UNITED STATES PATENT AND TRADEMARK OFFICE

| APPLICATION NO. | FILING DATE | FIRST NAMED INVENTOR | ATTORNEY DOCKET NO. | CONFIRMATION NO. |
|--|-------------|----------------------|---------------------|------------------|
| 10/757,175 | 01/14/2004 | Thomas M. Walraven | LTTKP0116US | 4188 |

| Office Action Summary | Application No. 10/757,175 | Applicant(s) WALRAVEN, THOMAS M. | |

DETAILED ACTION

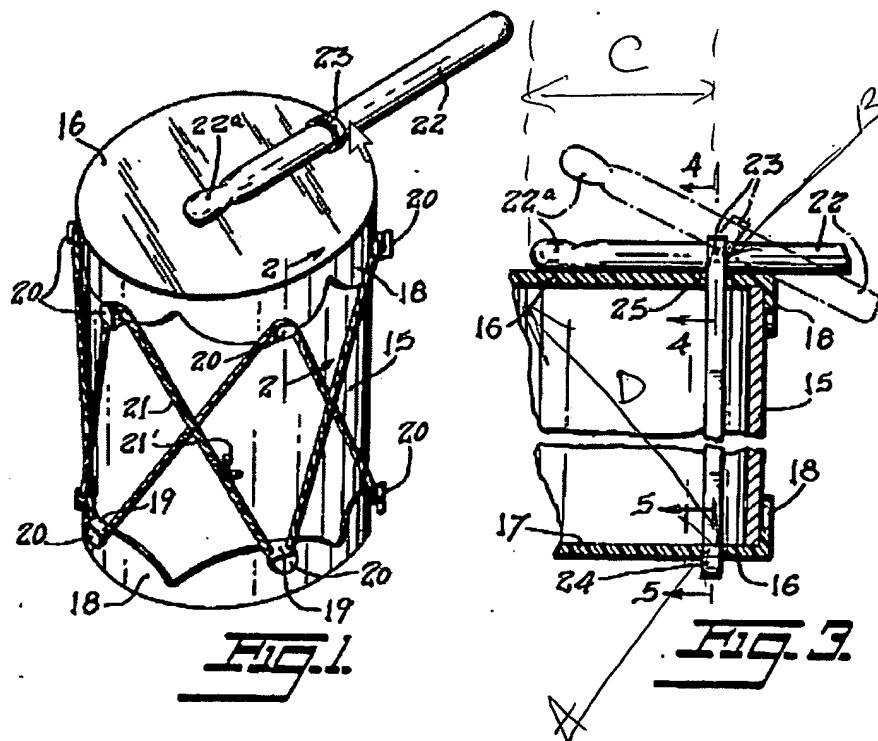
6. Claims 1, 3-4, 11, 21-22 and 25 are rejected under 35 U.S.C. 102(b) as being anticipated by Lebensfeld et al. [2,620,703], hereinafter Lebensfeld.

Lebensfeld discloses in Figs 1-9 (also see Figure below wherein the letter A-D have been added by the examiner), a toy percussion instrument, comprising: an instrument body 15, a striker/ implement [drumstick 22] for striking the instrument body to produce a sound; and a tether [resilient member 23] connecting the striker/ implement to the instrument body; wherein the tether has one end connected to the instrument body at a body attachment location A, and an opposite end connected to the striker/ implement at a striker/ implement attachment location B, the striker/ implement attachment location being fixed in relation to and spaced inwardly from the ends of the striker, and wherein the striker/ implement attachment location is spaced inwardly from

the ends of the striker by at least one fifth the length of the striker/ implement as recited in claim 1. Additionally, Lebensfeld discloses the striker/ implement attachment location is spaced inwardly from the ends of the striker/ implement by at least one fourth the length of the striker as recited in claim 3, the striker/ implement attachment location being fixed in relation to and spaced inwardly from the striker end of the striker/ implement by a distance C **about** equal the distance D between the body attachment location and a center of the drumming surface [in the absent of any definition in the specification and in so far as the applicant has claimed, the distance C is considered to be **about** equal to the distance D] as recited in claims 11, 22. Also, Lebensfeld discloses the striker/ implement attachment location is spaced inwardly from the ends of the striker implement by at least one fifth the length of the stricker/implement as recited in claim 21.

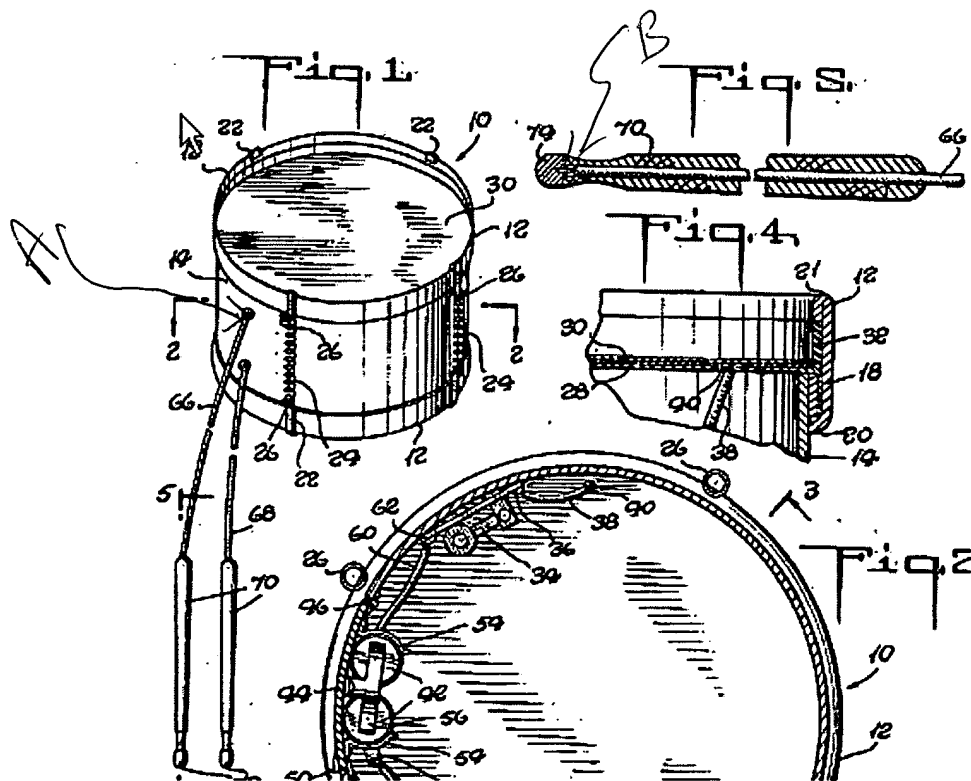
7. Claims 23 and 25 are rejected under 35 U.S.C. 102(b) as being anticipated by Levay [2,655,071].

Levay discloses in Figs 1-5 (also see Figure below wherein the letter A-B have been added by the examiner), a toy percussion instrument [drum 10], comprising: an instrument body 14, two striker/ implement [drumstick 70] for striking the instrument body to produce a sound; and a tether [wires 66 and 68] connecting the striker/ implement to the instrument body; wherein the tether has one end connected to the instrument body at a body attachment location A, and an opposite end connected to the striker/ implement at a striker/ implement attachment location B, the striker/ implement attachment location being spaced inwardly from the ends of the striker.
